ANN ARBOR BUILDING BOARD OF APPEALS

STAFF REPORT

Type of Request: VARIANCE

Building Board of Appeals Request **BBA17-010** at 211 W. Davis, ANN ARBOR, MI 48104.

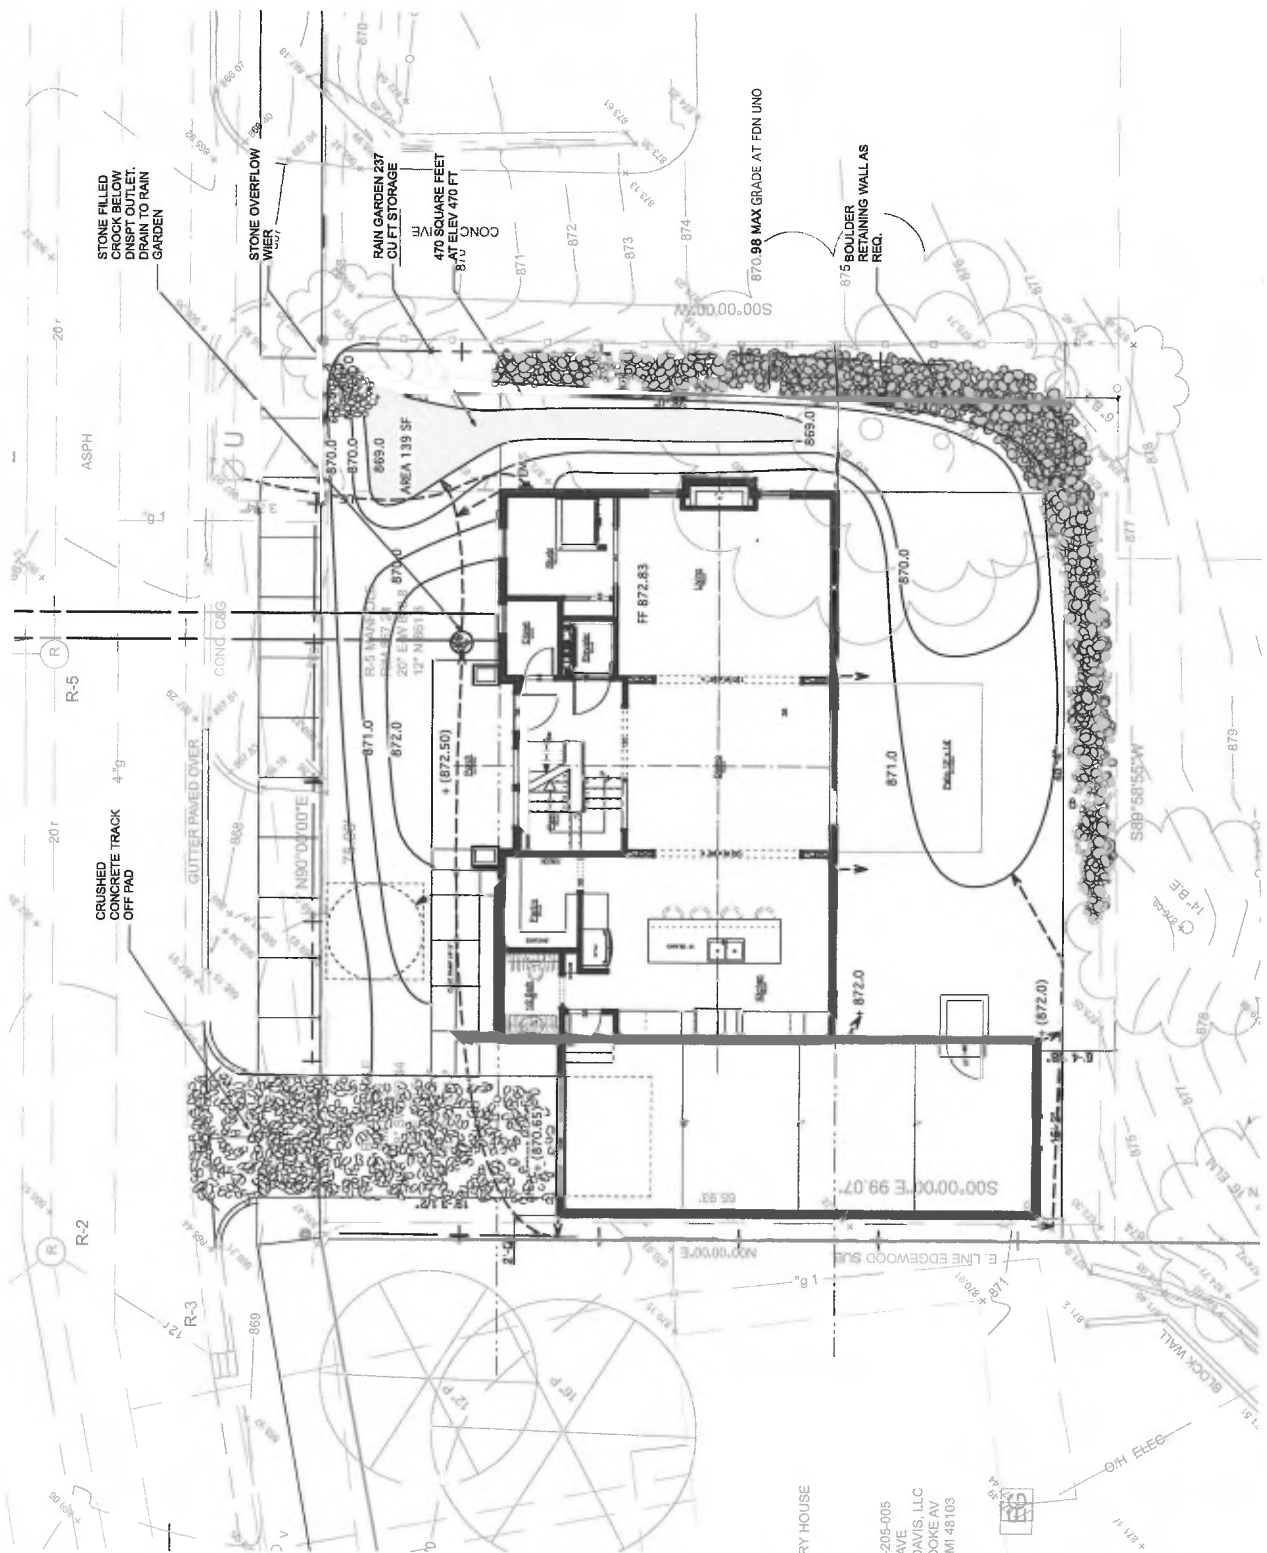
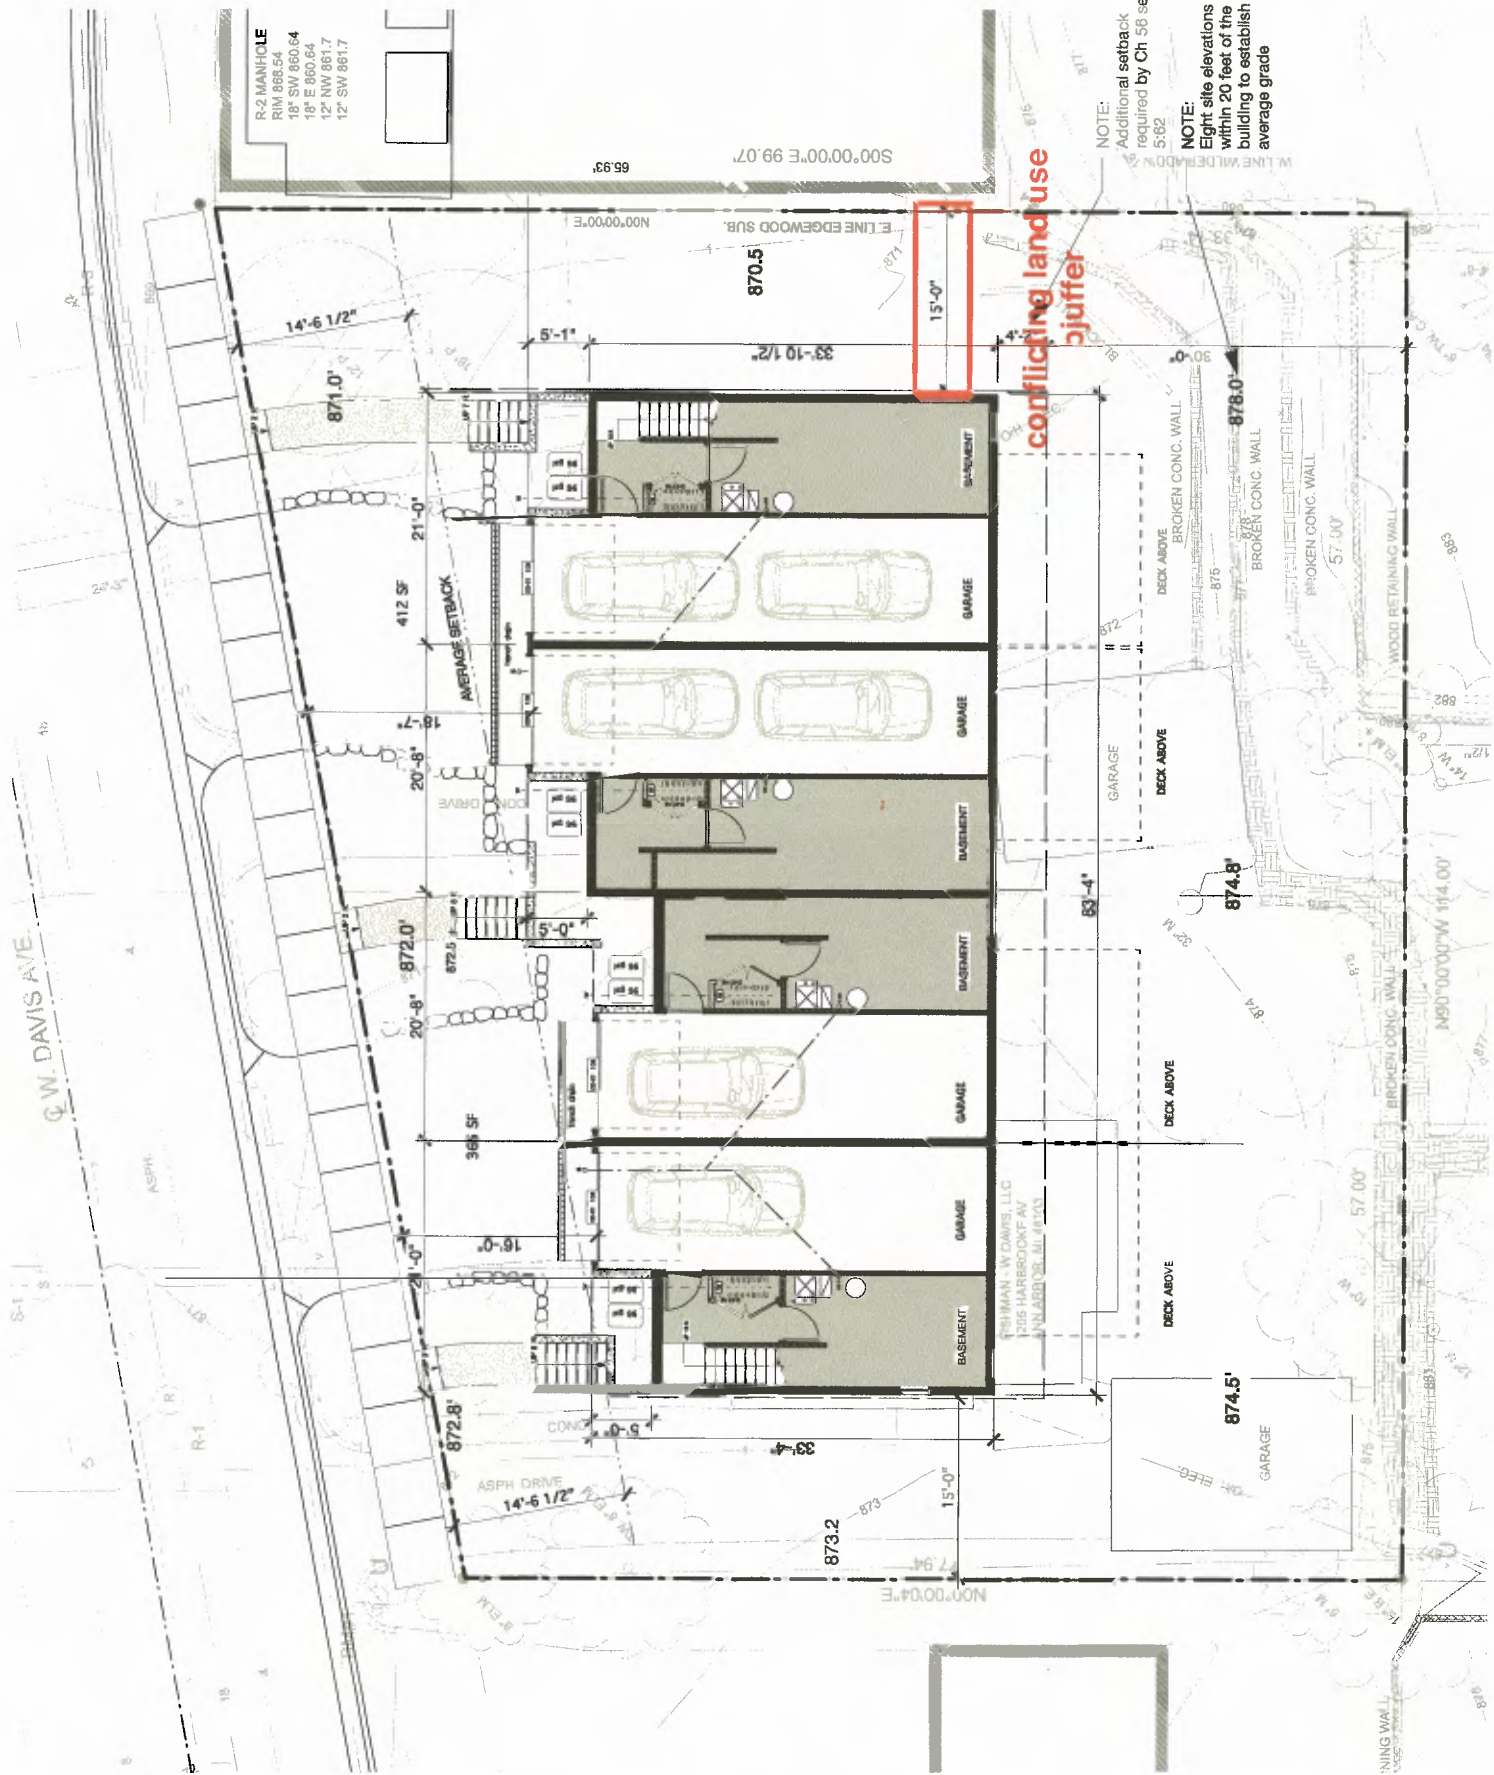
The applicant for the property at 211 W. Davis is appealing to the construction Board of Appeals that will allow the overhang projection a fire separation requirement to be less than two feet to the property line, which is not allowed per table 302.1(1) or 302.1(2) in the Michigan Residential Code 2015. The applicant has indicated that they would install a limited area sprinkler system for the garage and fire rate the soffit with blocking installed between the roof sheathing and top plate.

The Architect has indicated that the wall was set back 2 feet with a 12 inch overhang and that this would be allowed as he believes that I have interpreted the code incorrectly. He believes that the projection is allowed if the wall was 2 feet from the lot line and the eave projection with the soffit being fire rated and blocking installed between the roof sheathing and the top plate. As additional information the neighboring property has a required 15 foot conflicting land use buffer.

Code Interpretation: The Code Section R302.1 “**Exterior Walls.** Construction, projections, openings and penetrations of exterior walls of dwellings and accessory building shall comply with Table R302.1(1); or dwellings equipped throughout with an automatic sprinkler system installed in accordance with SectionP2904 shall comply with Table R302.1(2)” with some exceptions. This code section directs you to table 302.1(1) which does not allow any projection to get closer than a fire separation distance of 2 foot to the property line, with exception only to a perpendicular wall. Both tables, 302.1(1) & 302.1(2) do not allow you to have a projection any closer than two foot to a property line.

The new single-family residence's attached garage was set back from the side lot 2'0" with a 12" overhang. MRBC Table R302.1(1) was interpreted to allow projections into the wall setback if the wall was at least 2'0" from the lot line. While the MBC has a separate table for projections,

the MRBC places projections under the table for walls. This interpretation would allow for an eave projection if the soffit was fire rated and blocking installed between the roof sheathing and top plate. The building official disagreed with this interpretation.

As a further measure of public safety, the builder has proposed a limited area sprinkler system for the garage. The garage wall on the lot side will have a one hour fire rating and the house / garage separation wall will have a one hour fire rating. The garage will be in effect a separate fire area protected by sprinklers.
